Addendum No. 2
To the Plans, Specifications, Proposal and Contract

City of Kirkland
Fire Station 26 Renovation
9930 124th Ave NE, Kirkland, WA 98033
CIP # PSC 3006 000
JOB # 46-23-PW

ISSUED THIS DATE:	December 7th, 2023
BID SUBMITTAL TIME/DATE/LOCATION:	Prior to 1:00 P.M. on December 12, 2023 at Cashier - City of Kirkland 123 5th Avenue Kirkland WA 98033

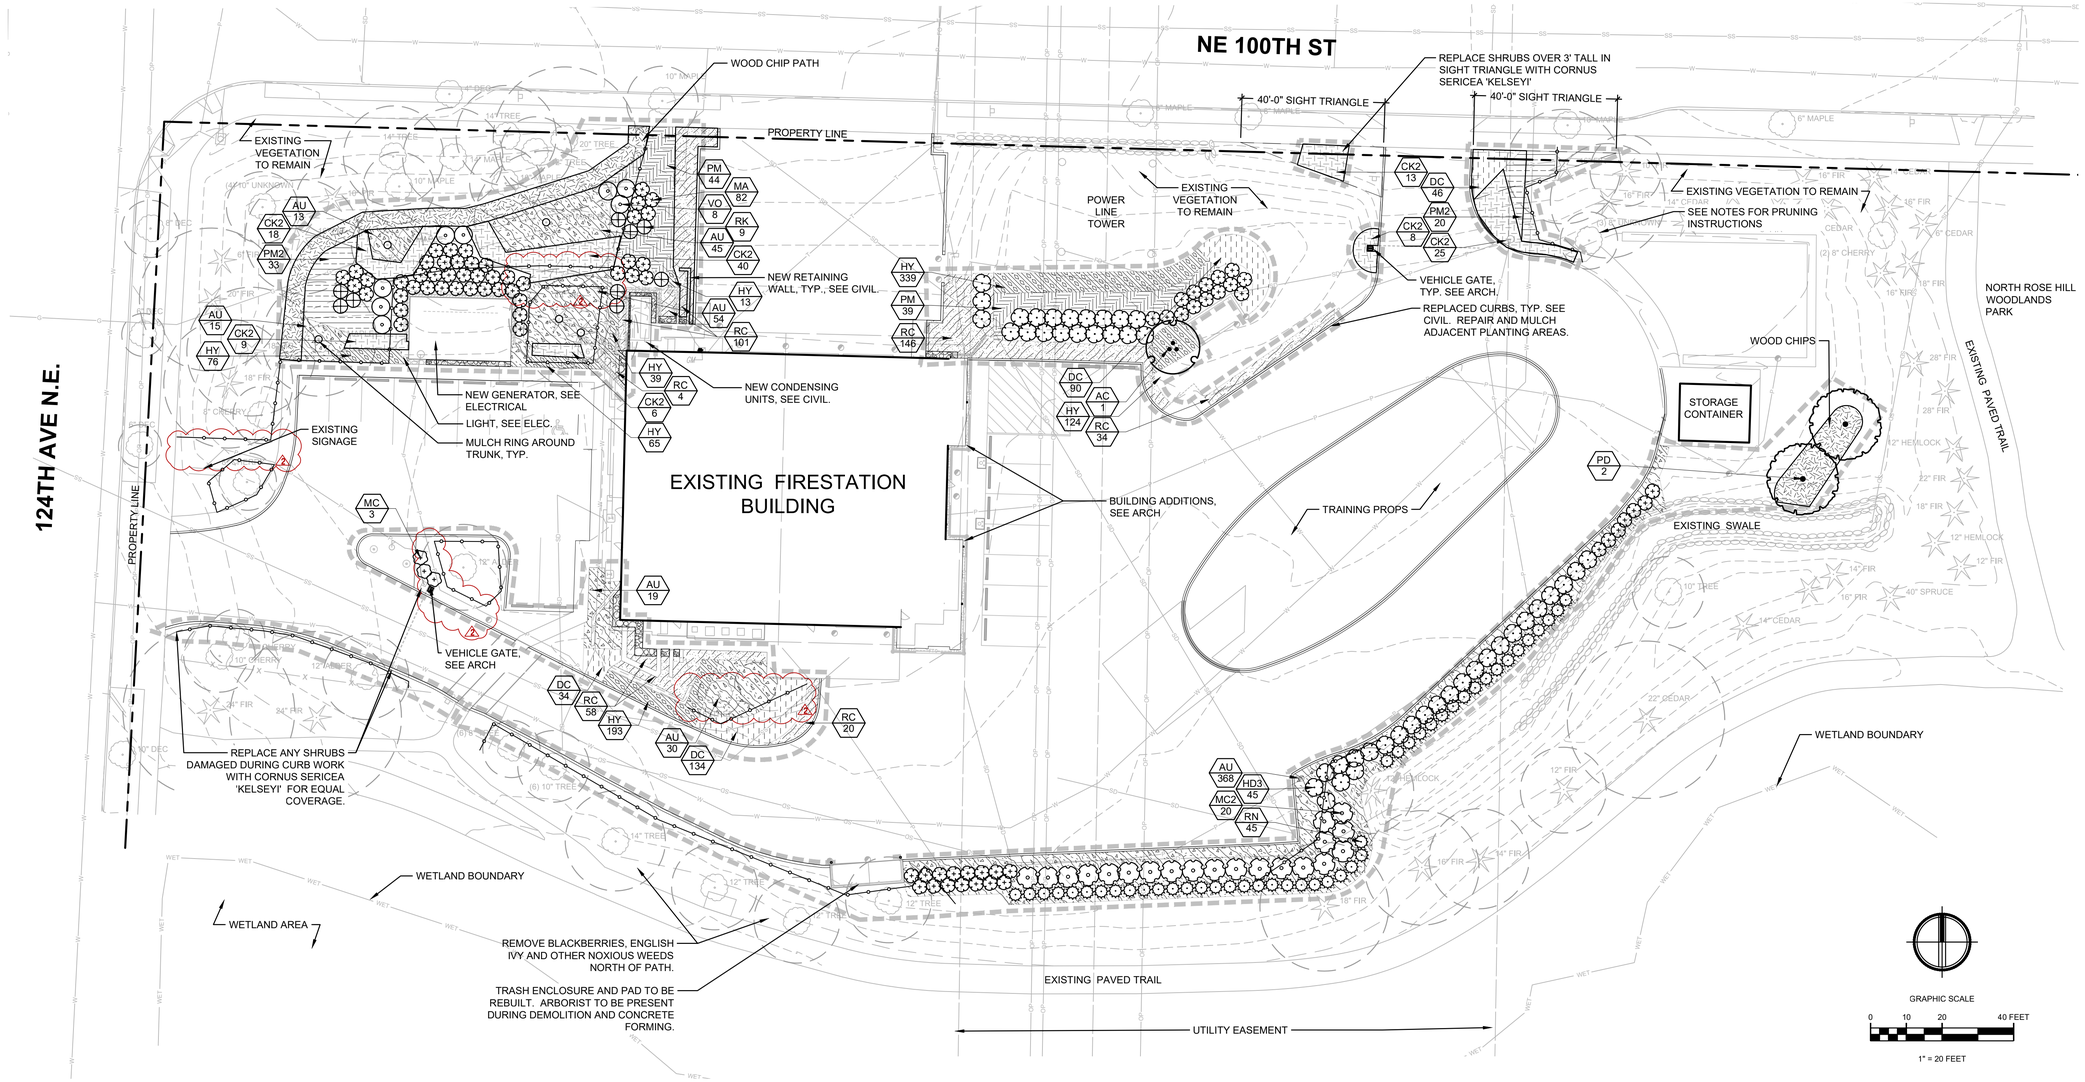
Item 1. L1.0 PLANTING PLAN
1. Replace sheet issued for bid with attached sheet dated December 7, 2023. Changes include:
   a. Revise tree protection fence extents to accommodate electrical trenching.

L1.0

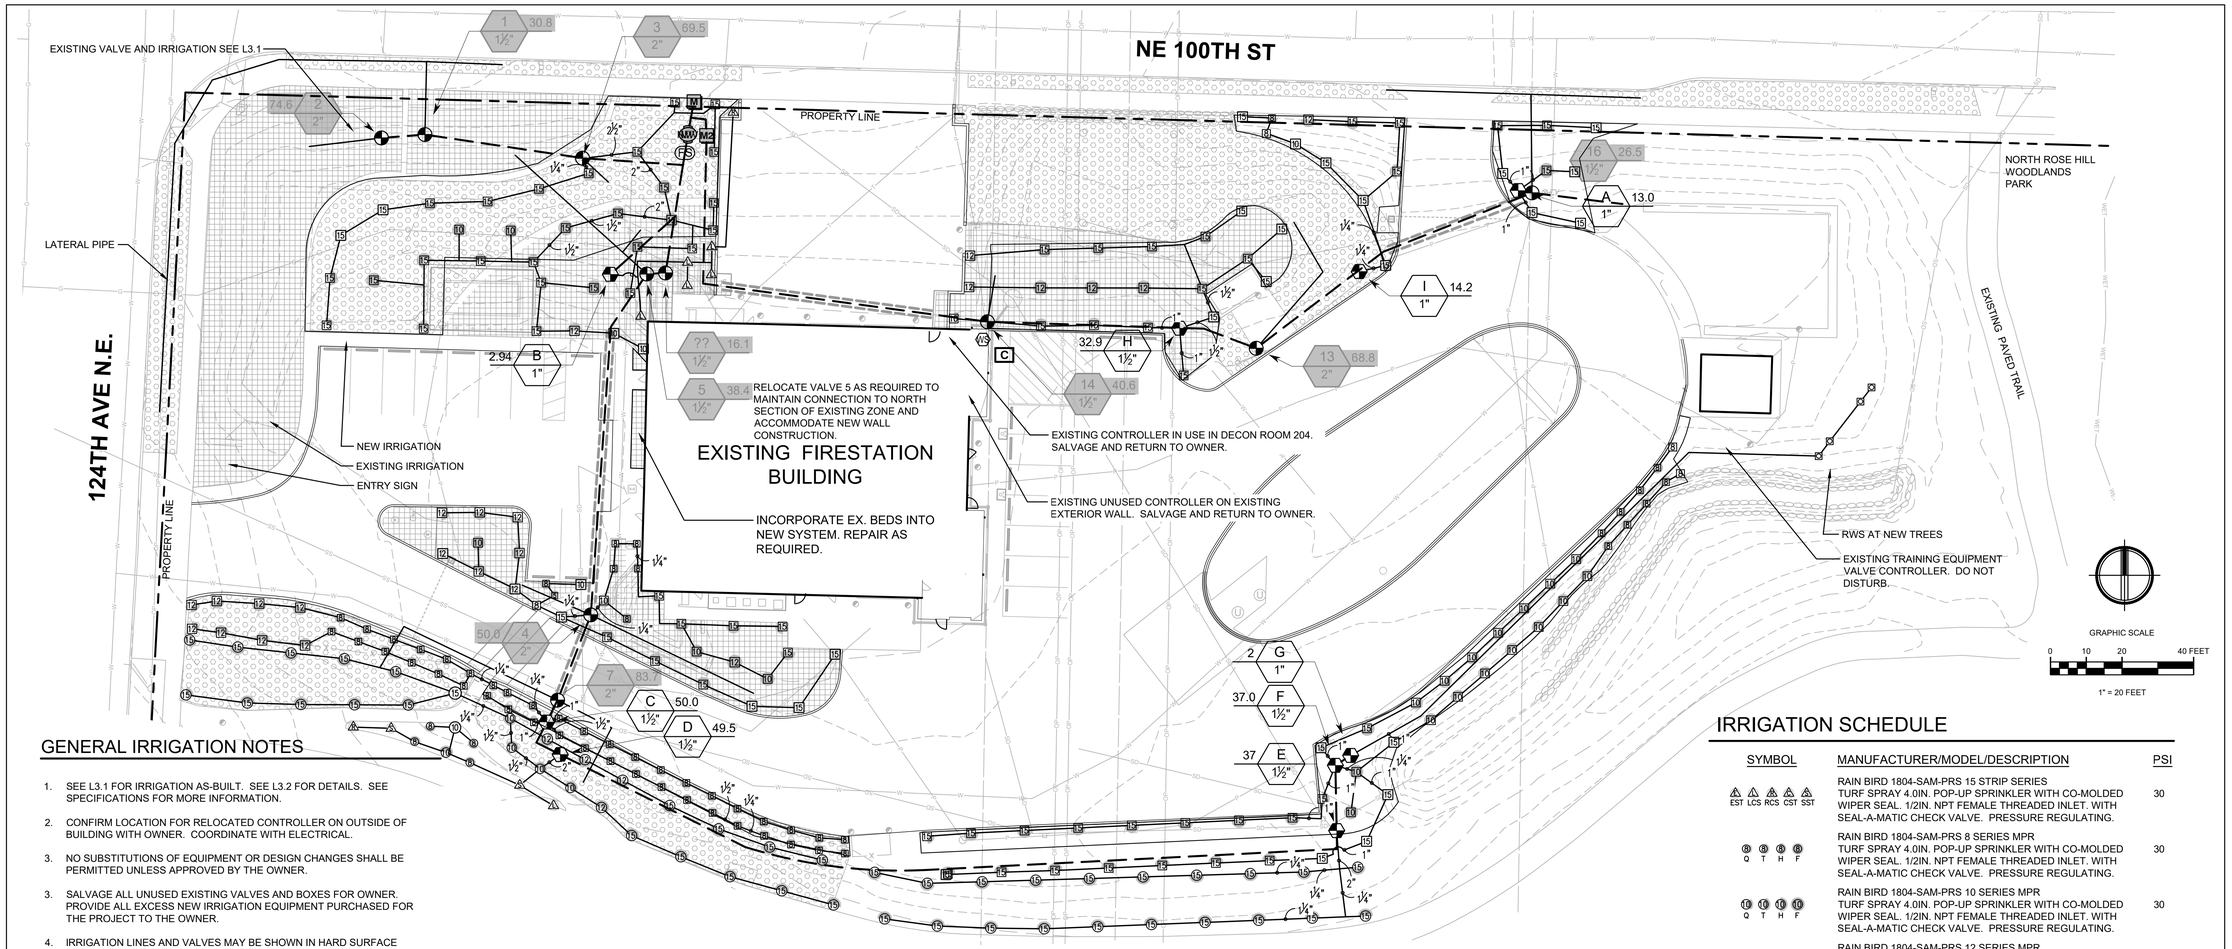
Item 2. L3.0 IRRIGATION PLAN
1. Replace sheet issued for bid with attached sheet dated December 7, 2023. Changes include:
   a. Change Master Valve to HUNTER IBV.
   b. Change Remote Control Valve to HUNTER ICV-G.
   c. Change flow sensor model to SLFSI-T15.

1 **SITE PLAN**
Scale: 1" = 20'-0"

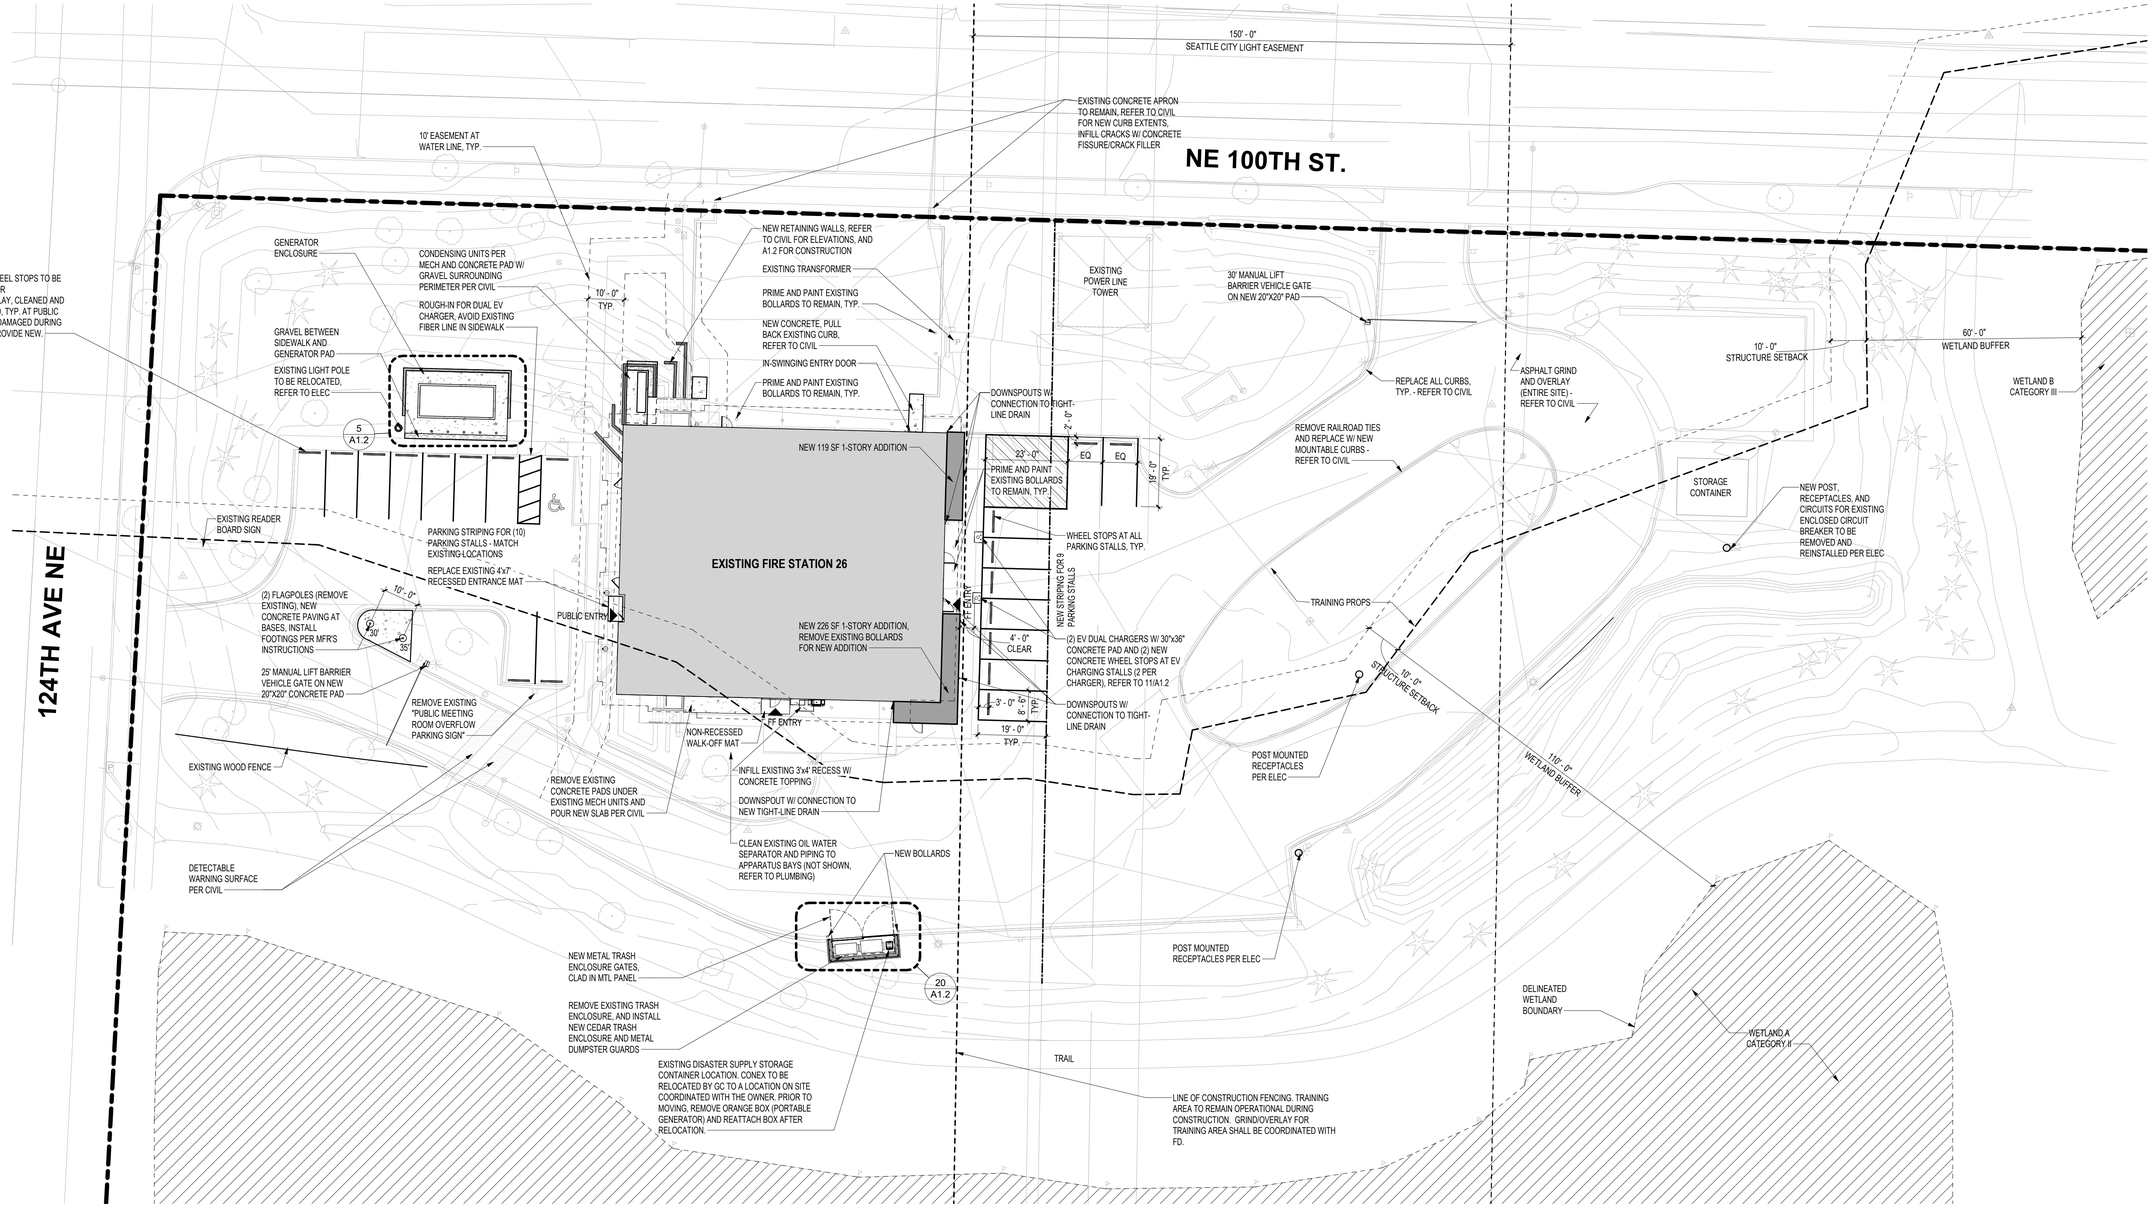
2. Replace sheet issued for bid with attached sheet dated December 7, 2023. Changes include:
    a. Dimensions provided for parking stall spacing and wheel stops.
    b. Southernmost site retaining wall shown with gray hatch to indicate a new wall per C3.00.

1 ROOF PLAN
Scale: 1/8" = 1'-0"

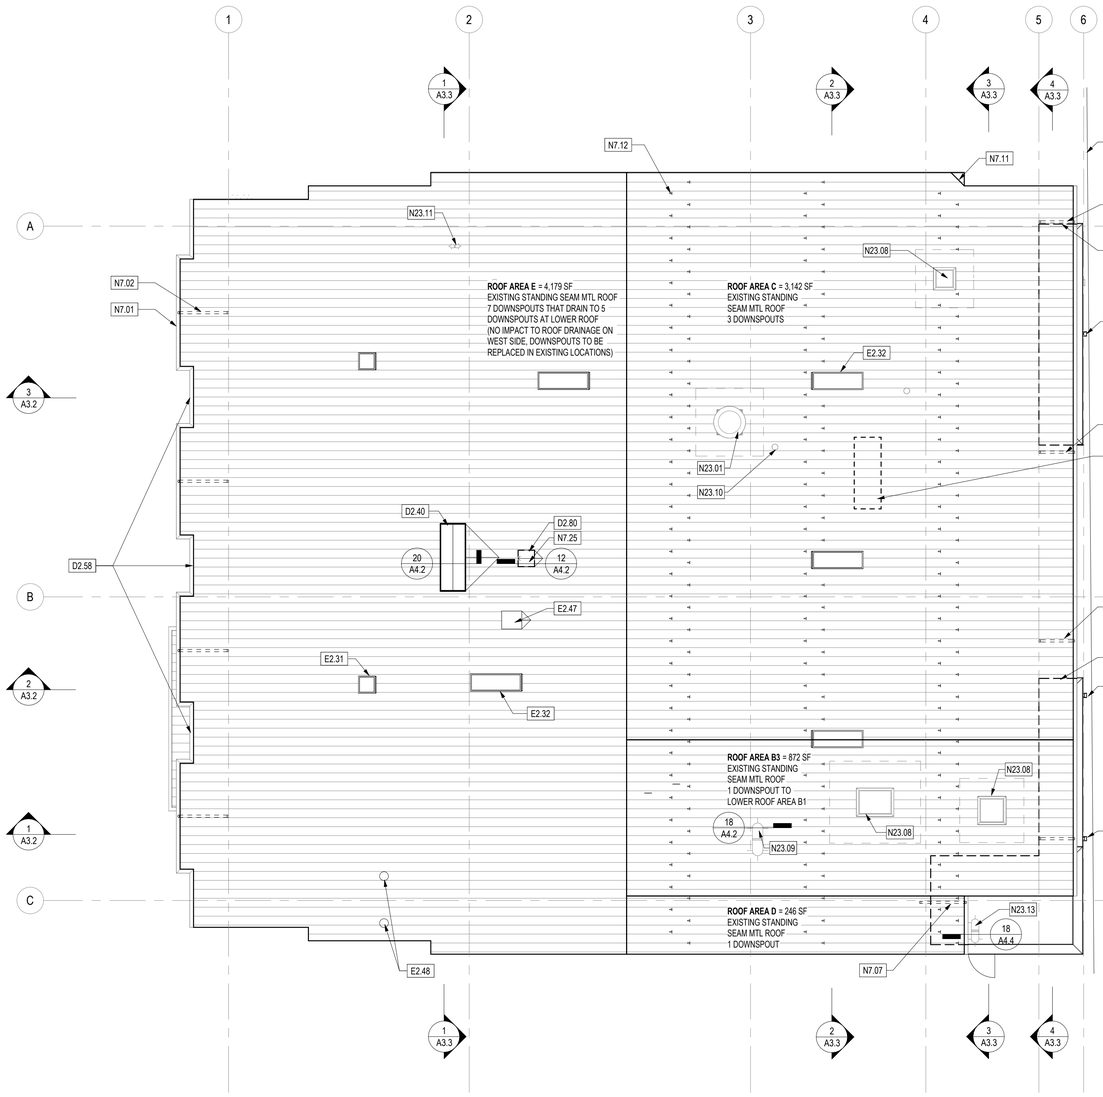
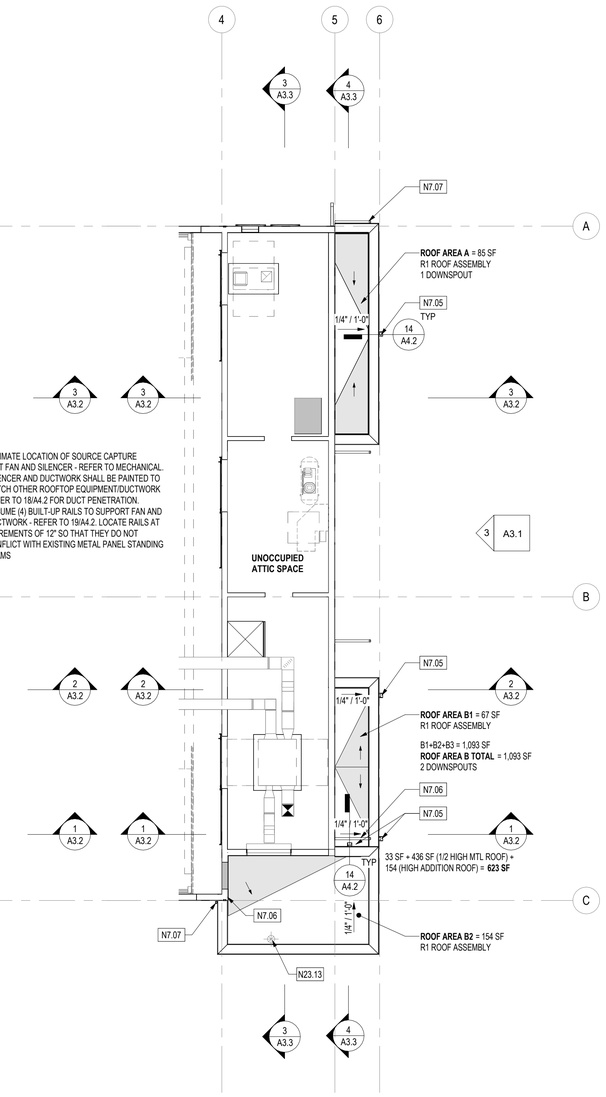
1. Replace sheet issued for bid with attached sheet dated December 7, 2023. Changes include:
    a. Addition of proposed location for source capture exhaust fan and silencer.
    b. Addition of notes and tags for support rails and duct penetrations.

18 DUCT PENETRATION @ MTL ROOF - UP/DOWN
Scale: 1 1/2" = 1'-0"

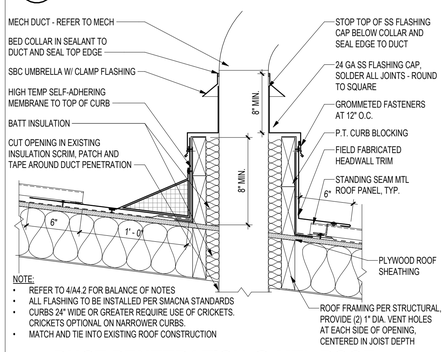
1. Replace sheet issued for bid with attached sheet dated December 7, 2023. Changes include:
    a. ADD detail 18/A4.2.
    b. ADD detail 19/A4.2.

DUCT PENETRATION AT PVC ROOF (NEW DETAIL REFERENCED FROM A2.7)

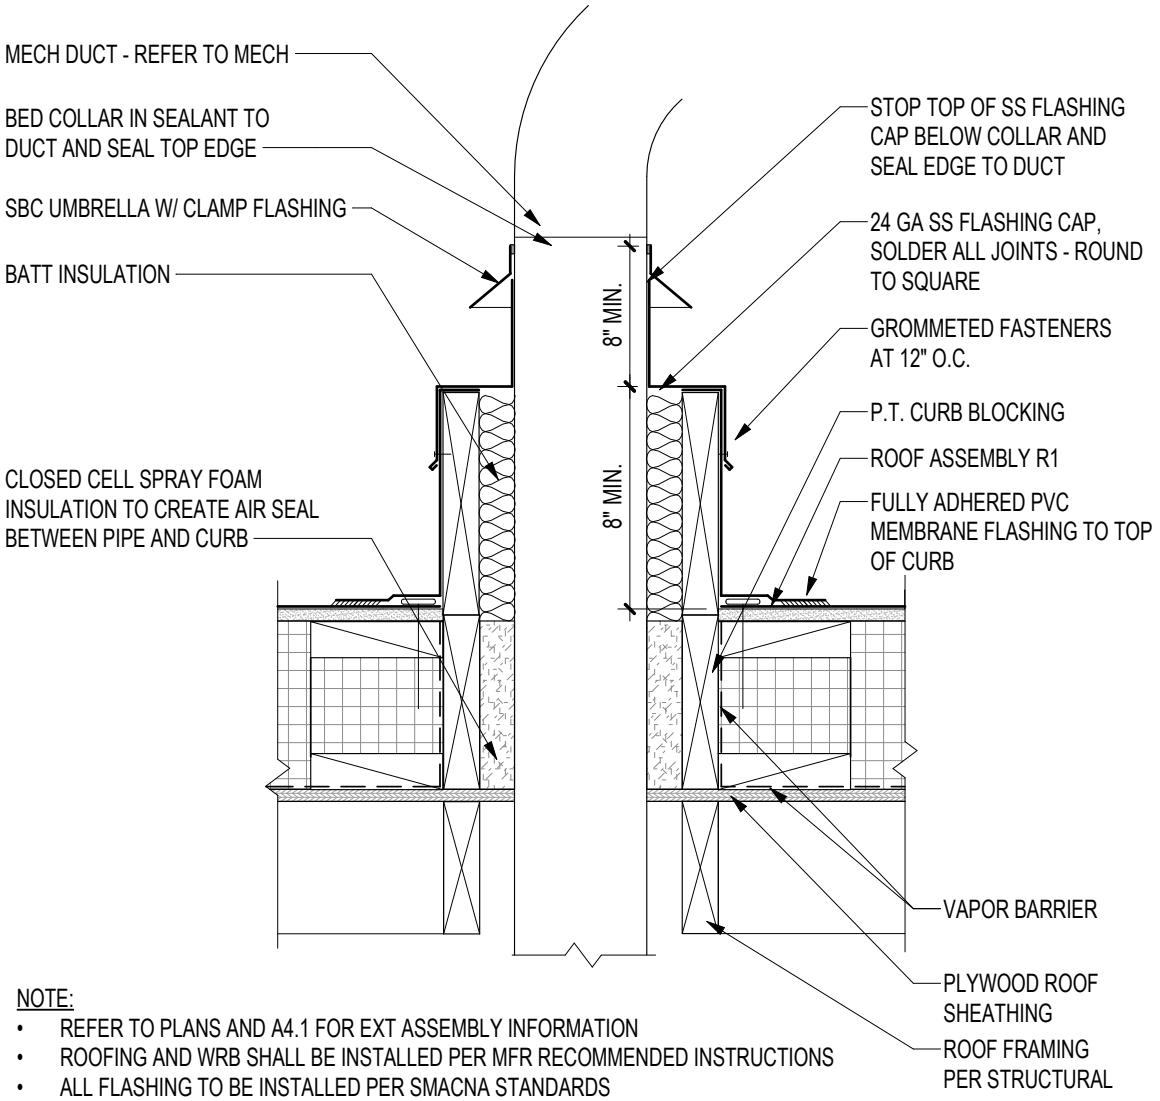
1. ADD detail 18/A4.4. Refer to AD 2 ASK-4.

1 105, 106 RESTROOMS

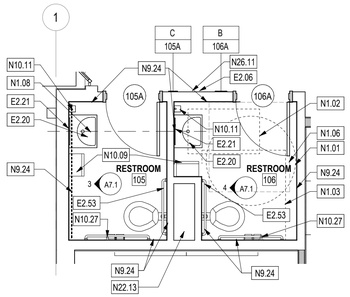
1. Replace sheet issued for bid with attached sheet dated December 7, 2023. Changes include:
    a. ADD keynote N5.02.
    b. 1/A5.1: Revisions to Restroom 106.
    c. 5/A5.1: ADD floor grate and dimensions.

13 FLOOR GRATE/CONC. BASIN SECTION AT FRWC

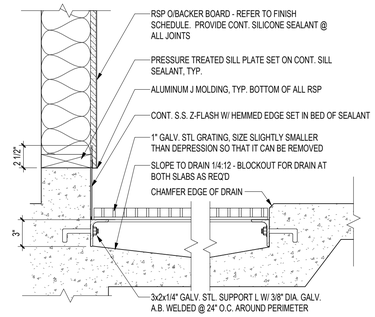
2. Replace sheet issued for bid with attached sheet dated December 7, 2023. Changes include:
    a. Revise 11/A8.3.
    b. ADD 13/A8.3.
